SAN ONOFRE NUCLEAR GENERATING STATION

IMPROVED TECHNICAL SPECIFICATIONS CONVERSION

ITS CHAPTER 4.0 DESIGN FEATURES

**Current Technical Specification (CTS) Markup
and Discussion of Changes (DOCs)**

Figure
4.1-1Figure 4.1-1 (page 1 of 1)
Exclusion Area Boundary

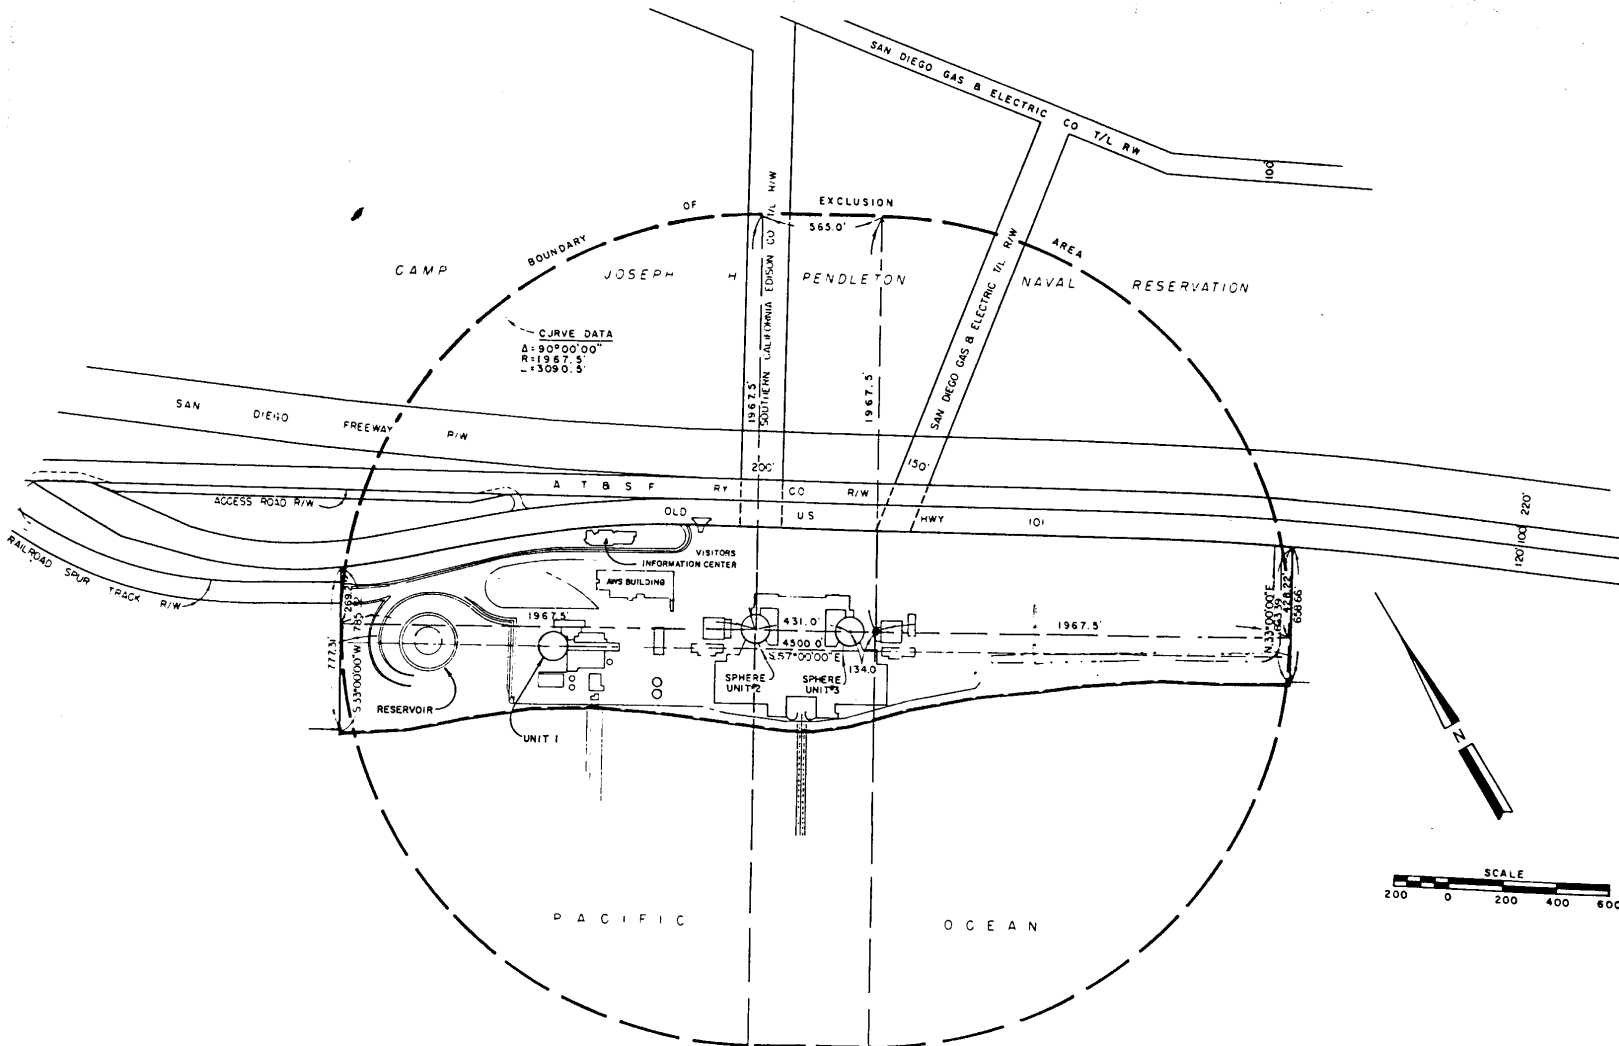
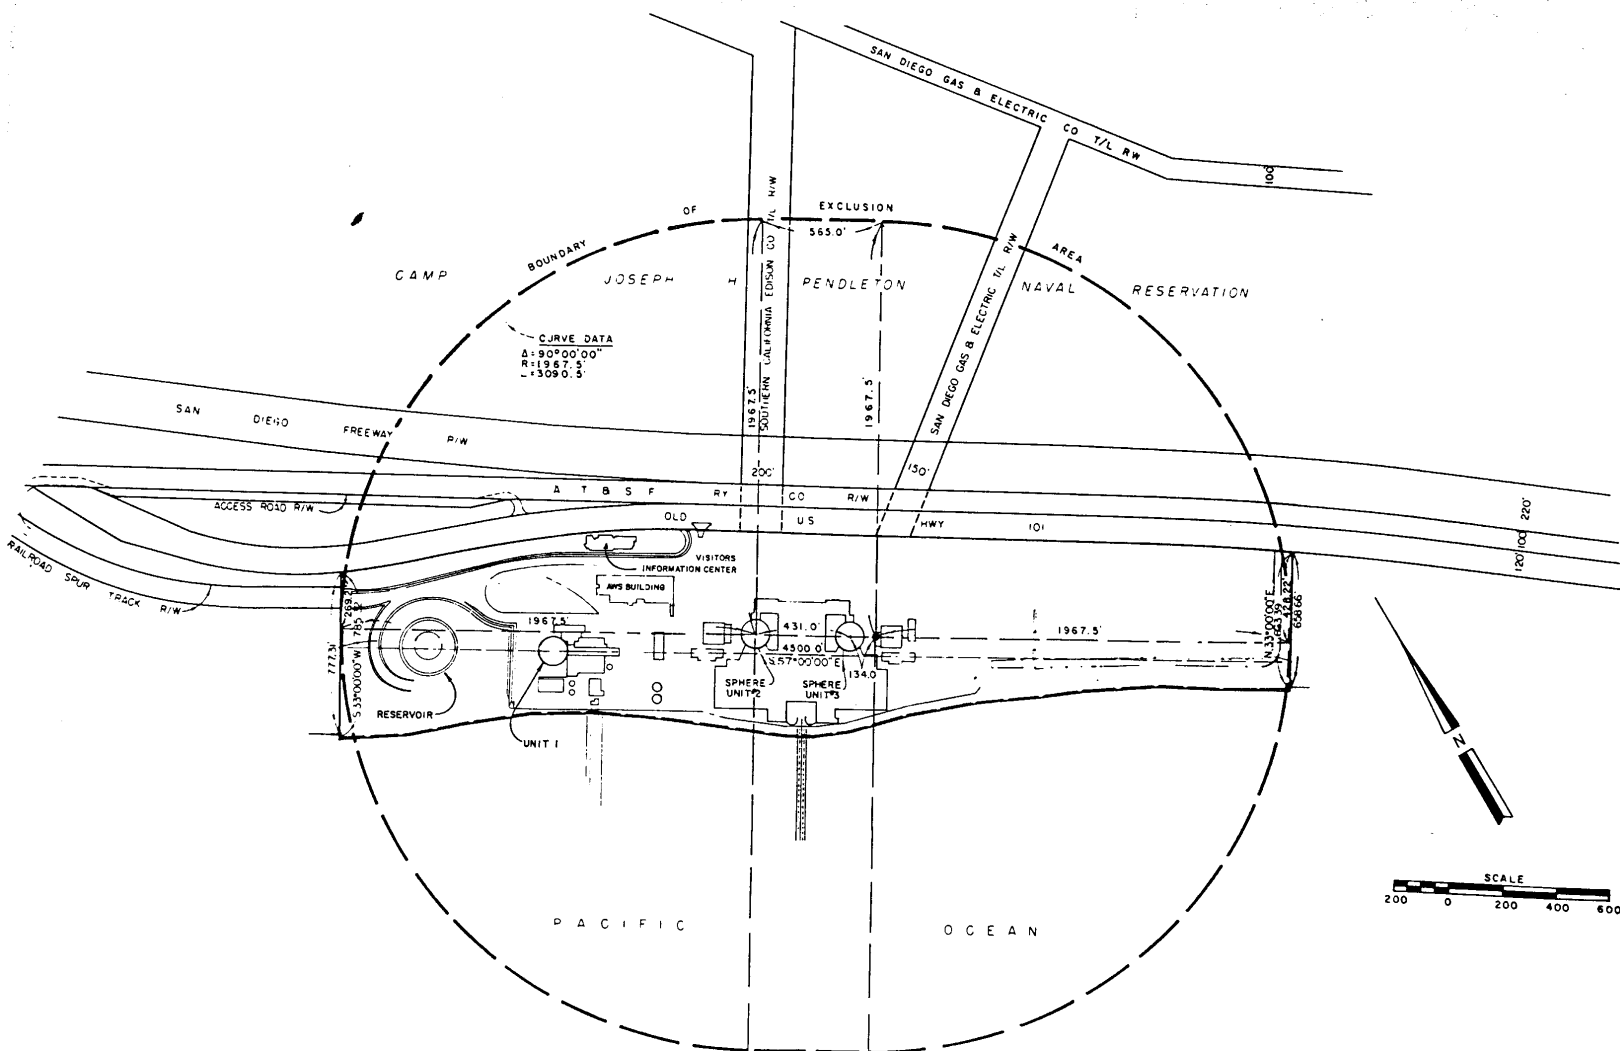
- A04 CTS Figure 4.1-1 shows the Exclusion Area Boundary, and includes a Reservoir, the Unit 1 containment structure, and a Visitors Information Center within the Exclusion Area Boundary. ITS Figure 4.1-1 also shows the Exclusion Area Boundary, but the drawing provided in the ITS has been modified such that the Reservoir is replaced with a Parking Lot, the Unit 1 containment structure is replaced with the ISFSI structure, and the Visitors Information Center is removed.

The purpose of providing the Exclusion Area Boundary in the Technical Specifications is to identify the locations of the possible radioactive release points and to show the dimensions of the boundary and the purpose of the Low Population Zone is to show the dimensions of the zone with respect to the plant. The ITS drawings have been updated to be consistent with the current Exclusion Area Boundary and Low Population Zone drawings in the UFSAR. The proposed changes do not affect the release points, nor the dimensions of the Exclusion Area Boundary or the Low Population Zone, associated with the SONGS Units 2 and 3 operating license. Therefore, since the ITS Figures are consistent with the figures in the UFSAR, this change is acceptable and is designated as administrative.

Figure 4.1-2 (page 1 of 1)
Low Population Zone

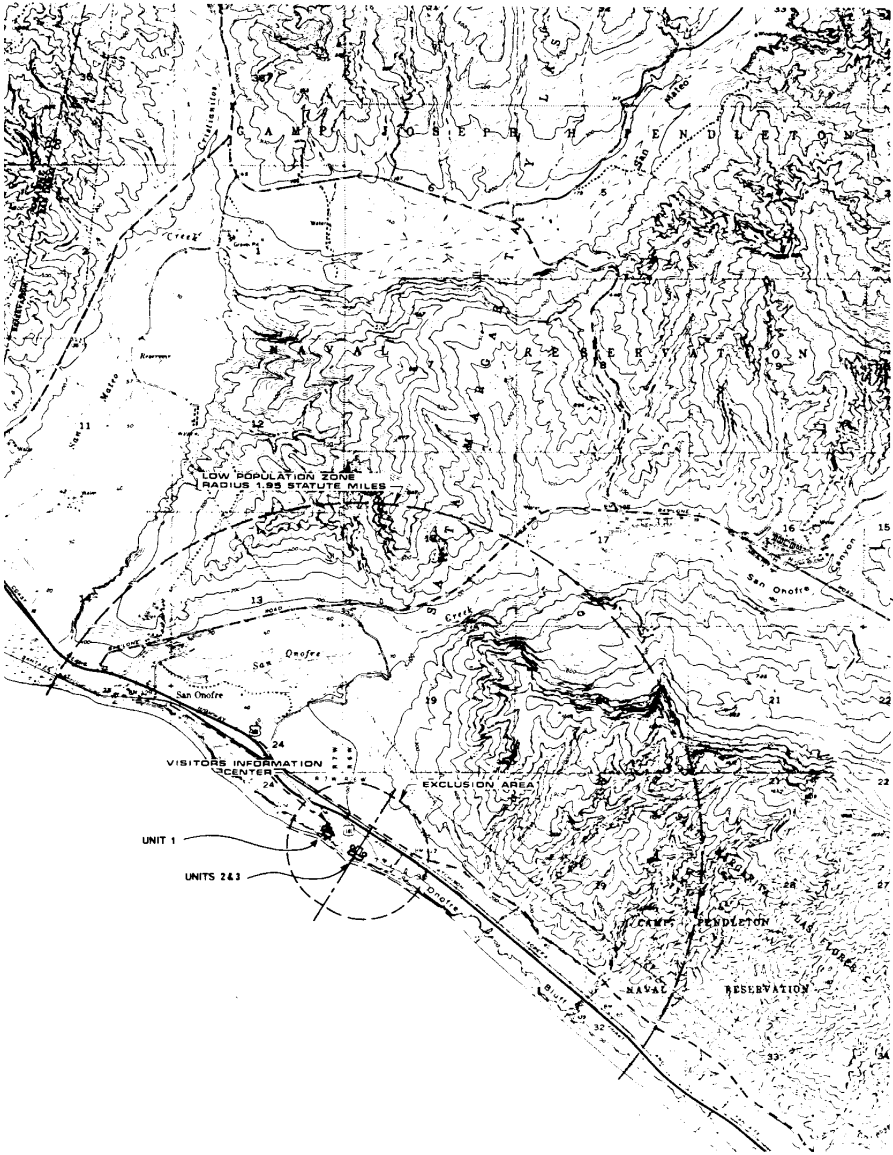
CTS Figure 4.1-2 shows the Low Population Zone, and includes the Unit 1 containment structure. ITS Figure 4.1-2 also shows the Low Population Zone, but the drawing provided in the ITS has been modified such that the Unit 1 containment structure is replaced with the ISFSI structure. This changes the CTS by updating the interior layout of certain features of the Exclusion Area Boundary and Low Population Zone.
